**TOWNSHIP OF SOUTH WHITEHALL
LEHIGH COUNTY, PENNSYLVANIA**

PLANNING COMMISSION

DECEMBER 16, 2021

DORNEYVILLE SHOPPING CENTER FAST CASUAL RESTAURANT

OVERALL SITE PLAN

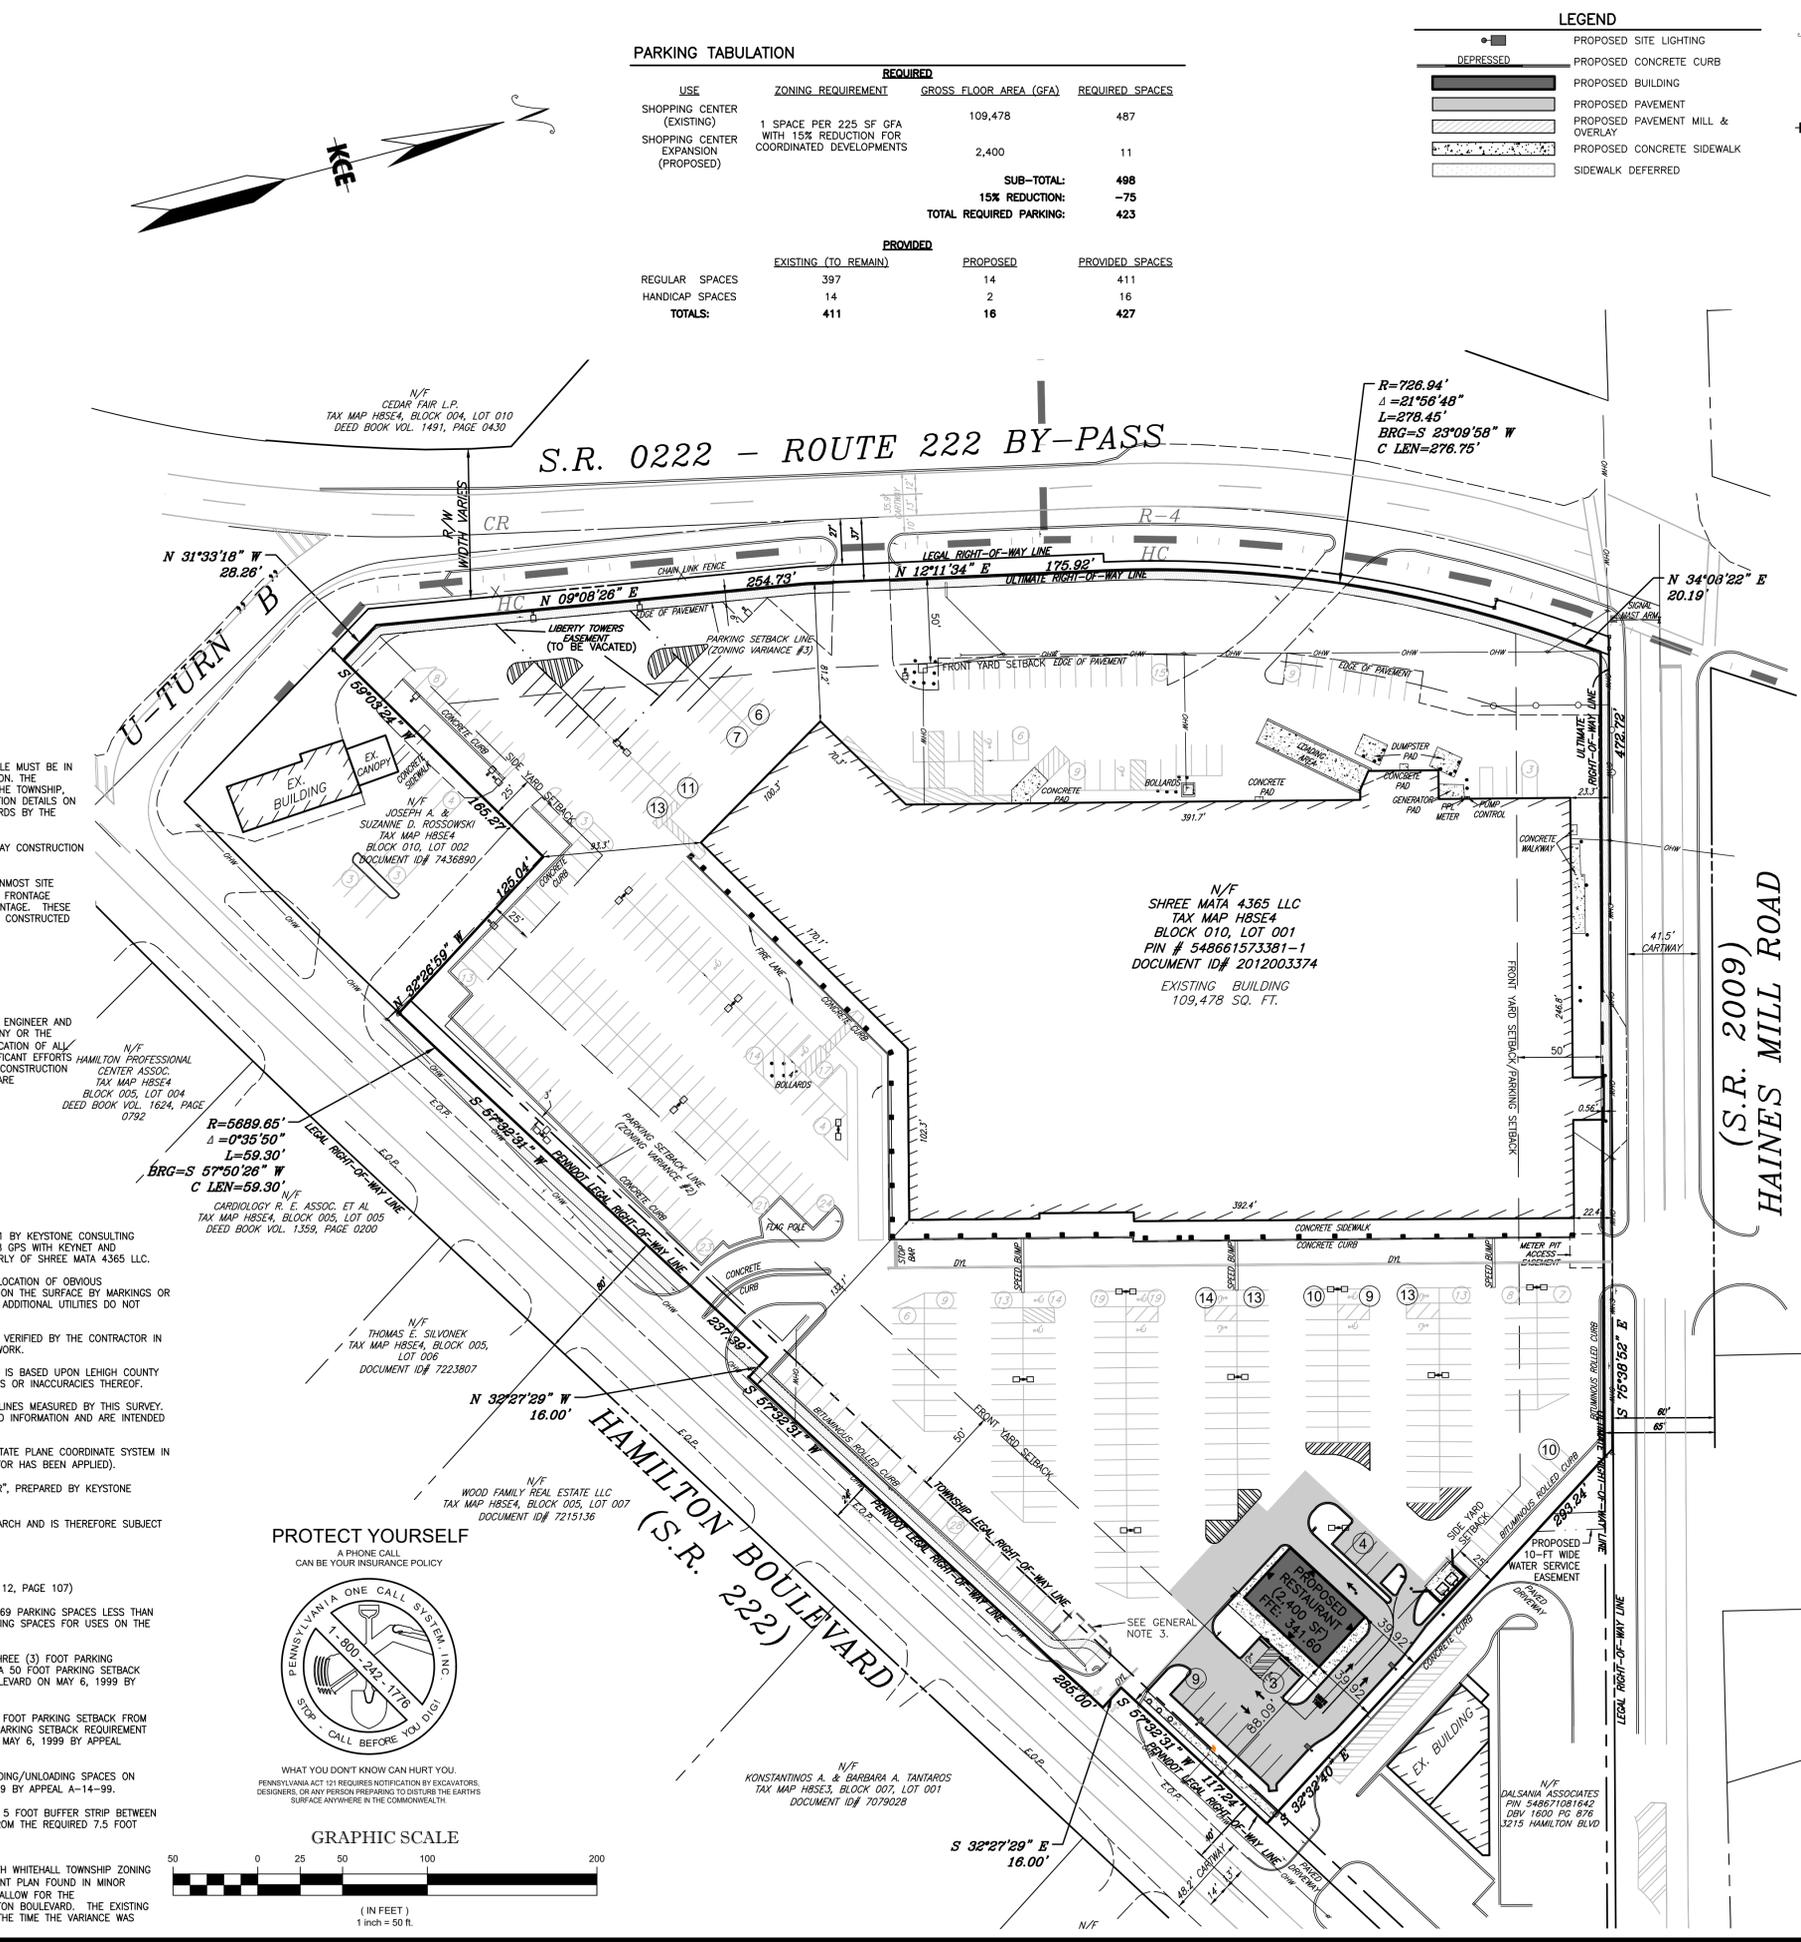
- 2. Survey Note 8 (Sheet 2) indicates that the Plan was prepared without the benefit of a Title Report and is therefore subject to any easements or other pertinent facts which such might disclose. Review the acceptability of this proposal with the Township Solicitor and address any comments to their satisfaction; and
- 3. The acceptability of the proposed number of parking spaces (427 parking spaces provided), the Coordinated Development 15 percent parking reduction, and Prior Zoning Relief Granted should be confirmed with the Township Staff and Zoning Officer.

GRADING & UTILITY PLAN
DORNEYVILLE SHOPPING CENTER EXPANSION
FAST-CASUAL RESTAURANT
3227 HAMILTON BOULEVARD
SOUTH WHITEHALL TOWNSHIP
LEHIGH COUNTY, PENNSYLVANIA

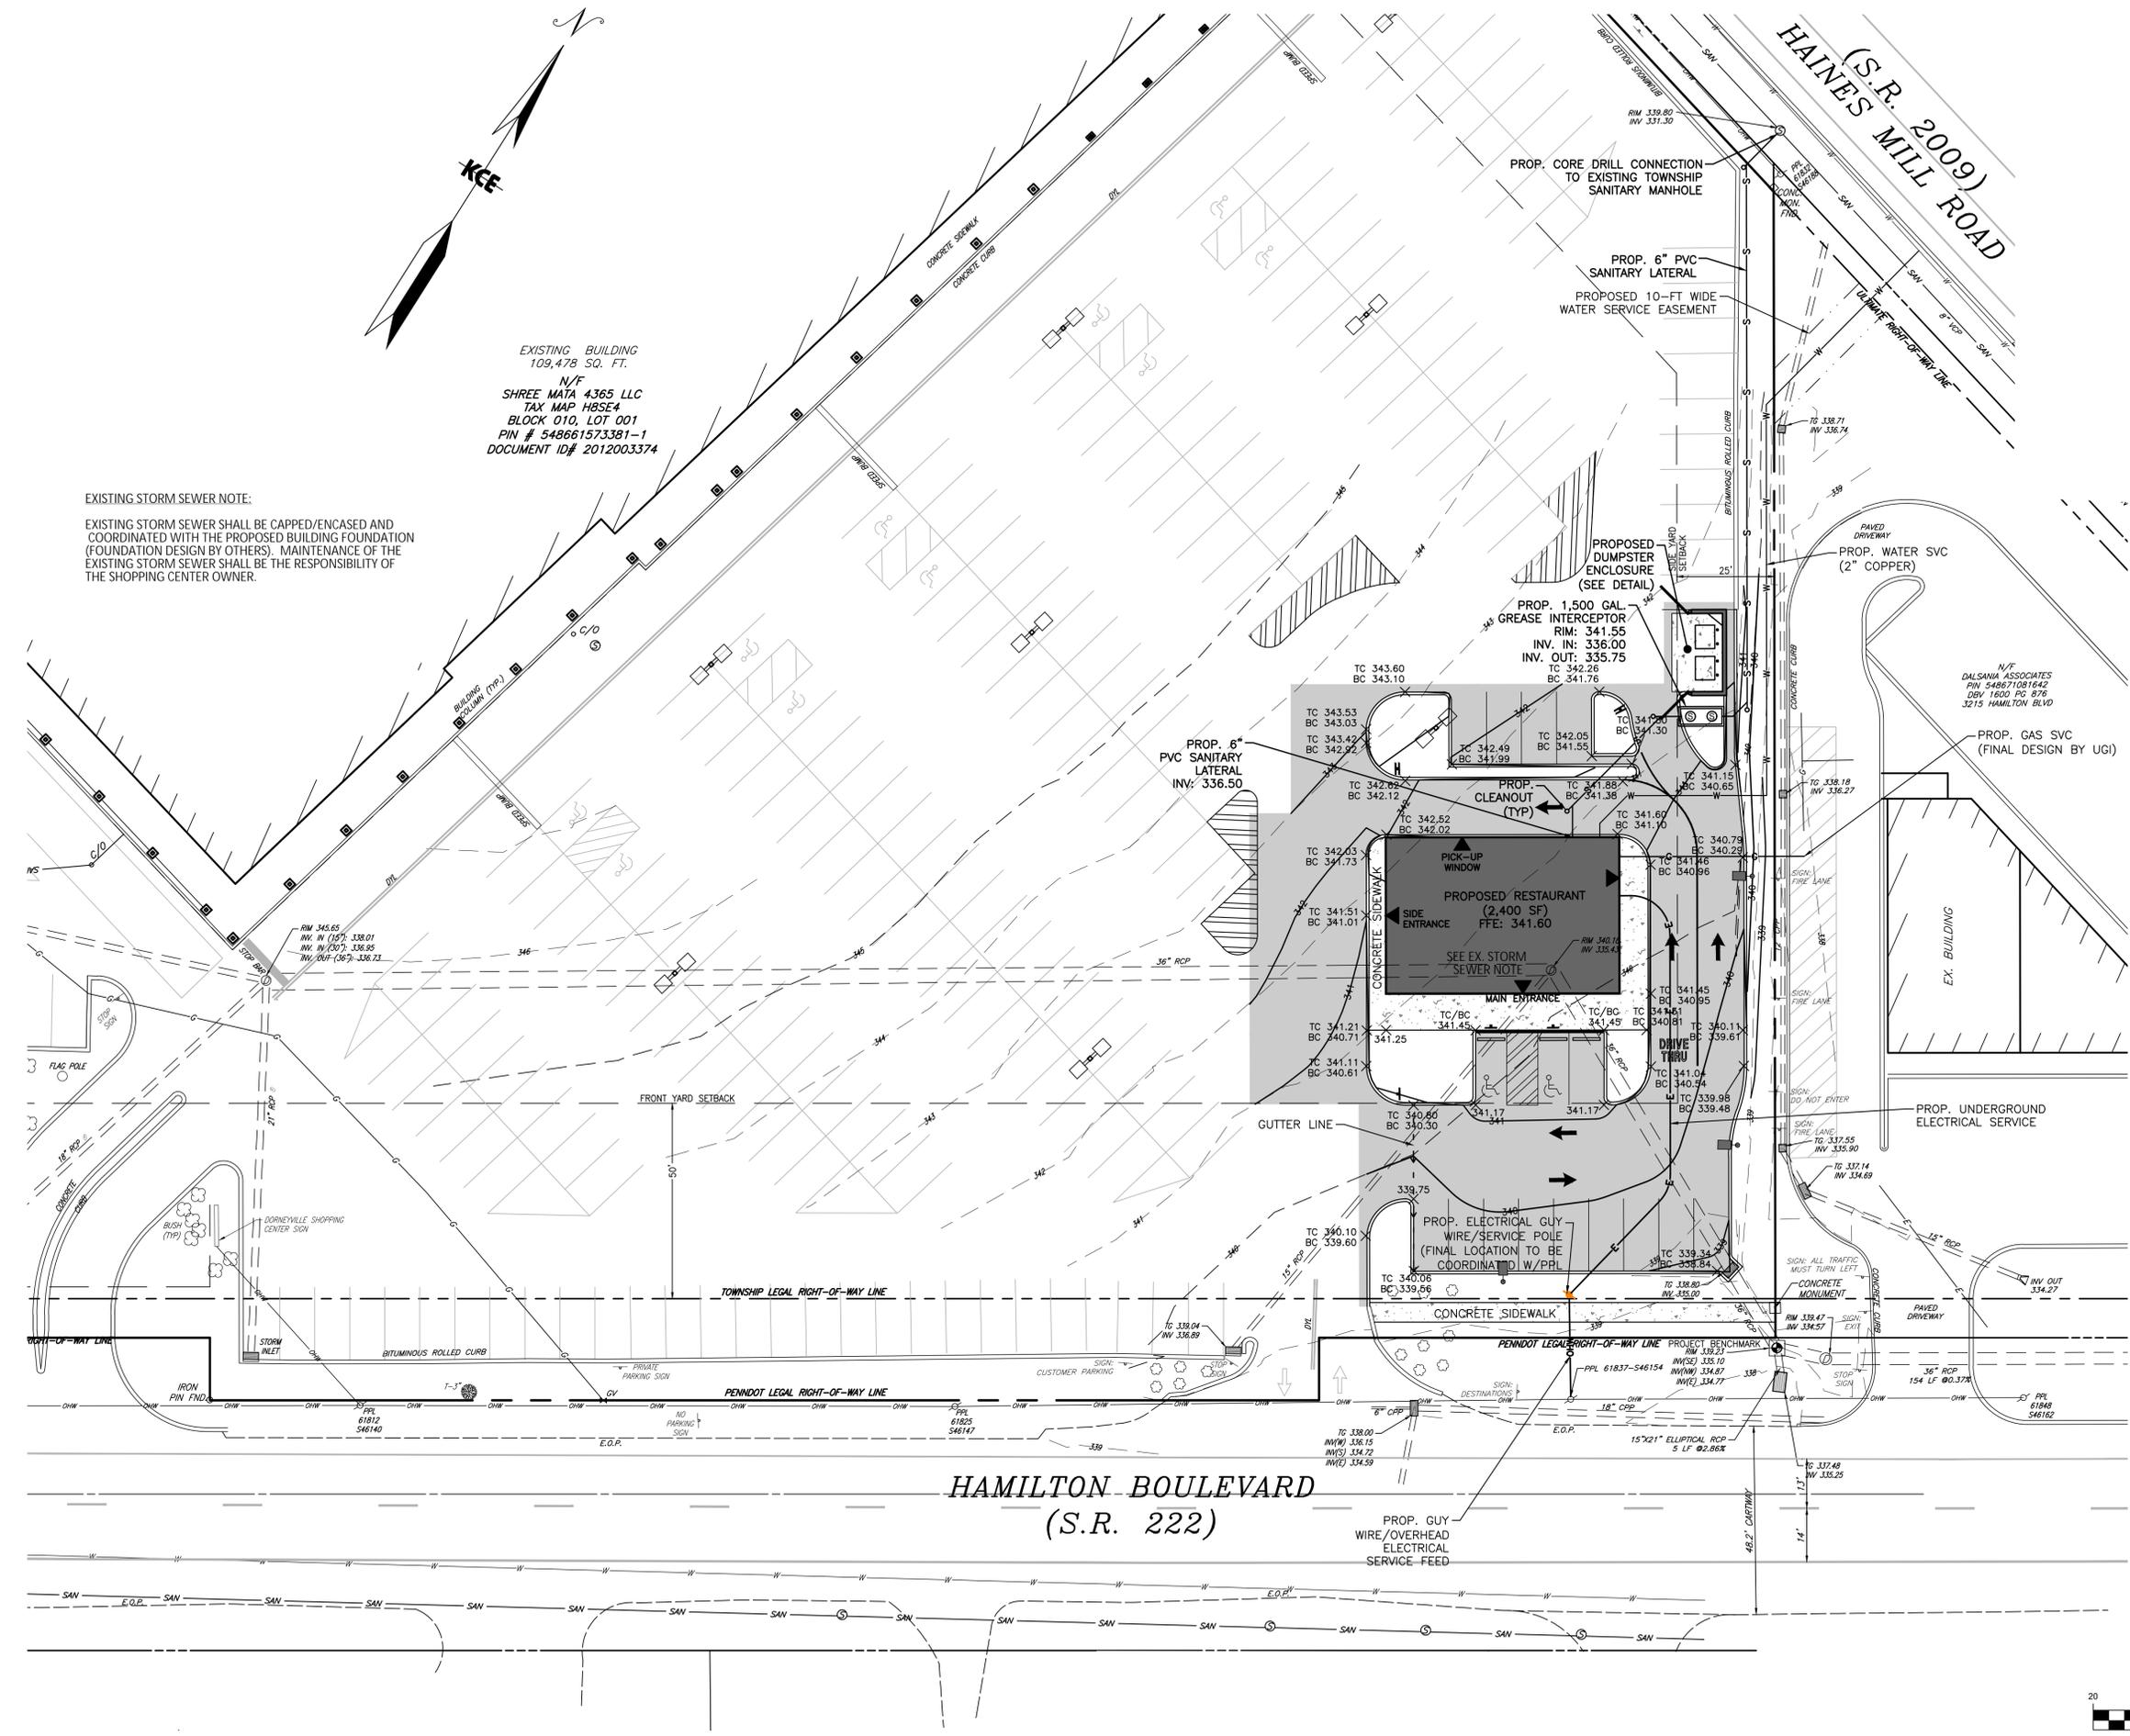
EXISTING STORM SEWER NOTE:
EXISTING STORM SEWER SHALL BE CAPPED/ENCASED AND COORDINATED WITH THE PROPOSED BUILDING FOUNDATION (FOUNDATION DESIGN BY OTHERS). MAINTENANCE OF THE EXISTING STORM SEWER SHALL BE THE RESPONSIBILITY OF THE SHOPPING CENTER OWNER.
